Access Compliance Report

Public Rights-of-Way

Intersection ID: 46315	Main Street: TYVOLA_RD	Cross Street: MARGELLINA_DR	Location: N
ADA ID: 0EA59EC90DC6	Ramp Type: ParaDiag	Initial Pass/Fail: Fail	Overall Compliance: No
			Severity Score: 26.25

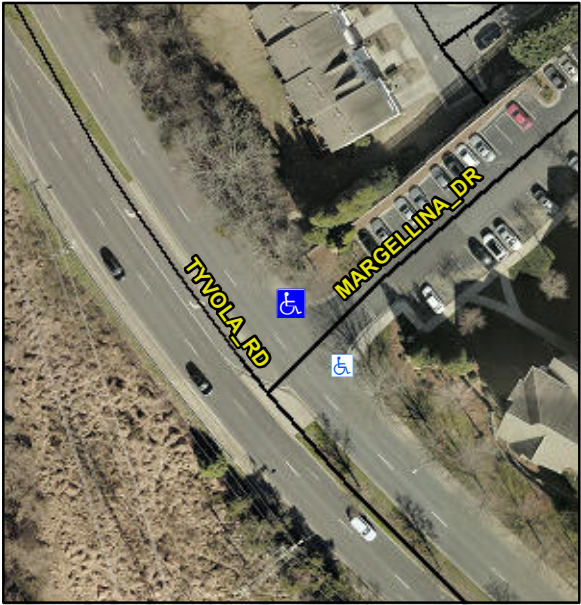
Codes/Mitigation Info/Possible Solution			Field Measurements/Component Compliance		
	Possible Solutions:		Compliance	Description	Data
	Remove & Replace Curb Ramp With Two New Directional Ramps or Equivalent.		N/A	Ramp Length LT (in)	44.0
			Yes	Ramp Width LT (in)	59.5
			Yes	Ramp Slope LT (%)	3.7
			Yes	Ramp XSlope LT (%)	0.0
			N/A	Landing Length (in)	N/A
			N/A	Landing Width (in)	N/A
			N/A	Landing Slope (%)	N/A
			N/A	Landing X Slope (%)	N/A
			N/A	Landing Curb? (Y/N)	N/A
<p>Surveyor Notes:</p> <p>MEDIAN ACROSS TYVOLA RD, LT RP < 5%</p> <p>PROW/ADA:</p> <p>R304.3.2, R304.5.3</p>			N/A	Ramp Length RT (in)	54.0
			Yes	Ramp Width RT (in)	60.0
			No	Ramp Slope RT (%)	16.3
			No	Ramp XSlope RT (%)	2.6
			N/A	DWS Provided?	N/A
			N/A	DWS Contrast?	N/A
			N/A	DWS Length (in)	N/A
			N/A	DWS Full Width?	N/A
			N/A	DWS Offset (in)	N/A
			N/A	Gutter Slope (%)	N/A
<p>Total Cost:</p> <p>\$ 3200.00</p>			N/A	Gutter X Slope (%)	N/A

No	Painted X Walk2?	No
			To SW	X Walk 2 Direction	To SE
			N/A	X Walk 2 Width (in)	N/A
			6.5	X Walk 2 Slope (%)	3.5
			4.8	X Walk 2 X Slope (%)	2.7
			N/A	Ramp inside XWalk2?	N/A

7.4	Clear Space?	N/A
			3.1	Clear Space to XWalk (in)	N/A
			N/A	Storm Grate/Utility Hazard?	N/A
<p>Obstruction Type</p>			N/A	Storm Grate/Utility Type	N/A
			N/A	Surface Condition? (G/P)	Good
			N/A	Curb Slope (%)	15.1
